Product Safety Recall

N202322230 Seat Belt May Not Be Properly Attached

Release Date: December 2020

Condition	General Motors has decided that a defect which relates to motor vehicle safety exists in certain 2020 model year Chevrolet Bolt EV vehicles. In these vehicles, the wrong seat-belt bolt may have been used at one or more fastening locations to secure the seat belt to the vehicle. If an incorrect bolt was used, the seat belt may not be properly attached to the vehicle. If a seat belt assembly is not properly attached to the vehicle, the seat belt may not properly restrain an occupant, increasing risk of occupant injury in a crash.
Correction	Dealers will replace bolts at suspect seat-belt attachment locations.

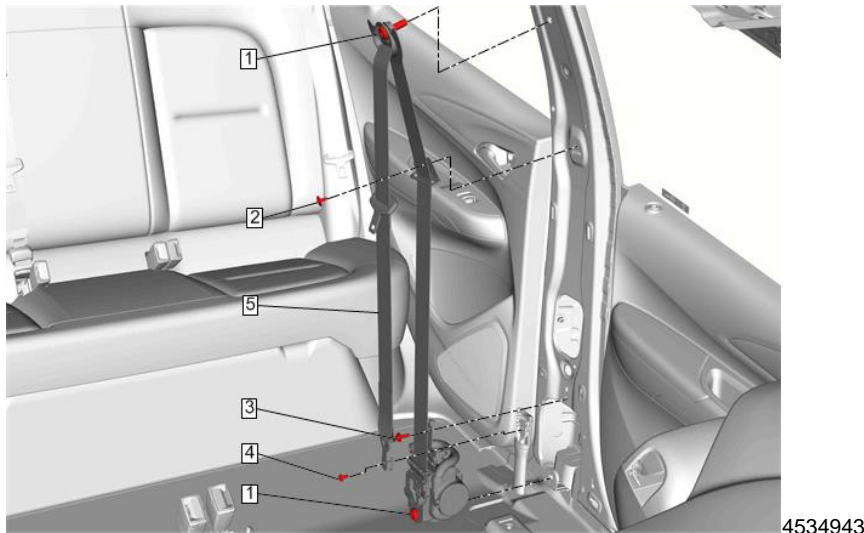
Note: The LH side is shown for reference purposes only.

2. Remove and discard the lower retractor bolt (1).
3. Install the new retractor mounting bolt. Refer to the note above for installation details. Tighten the new service bolt to 45 N.m (33 lb. ft).
4. Reinstall the center pillar lower trim panel. Refer to *Center Pillar Lower Trim Panel Replacement* in SI.

NOTE: The bolt being removed from the vehicle may not have cut the proper threads in the nut when the vehicle was manufactured. If this occurred, expect to feel resistance for the complete bolt length when removing the bolt. When the new bolt is being installed in an unthreaded nut, there will be resistance as the self-threading bolt threads the nut. There will be an initial resistance while the thread is being cut, followed by a reduction in resistance. This is an expected condition. Continue tightening the bolt until the retractor or belt bracket is secured. To complete the installation, tighten the bolt to the proper torque specification.
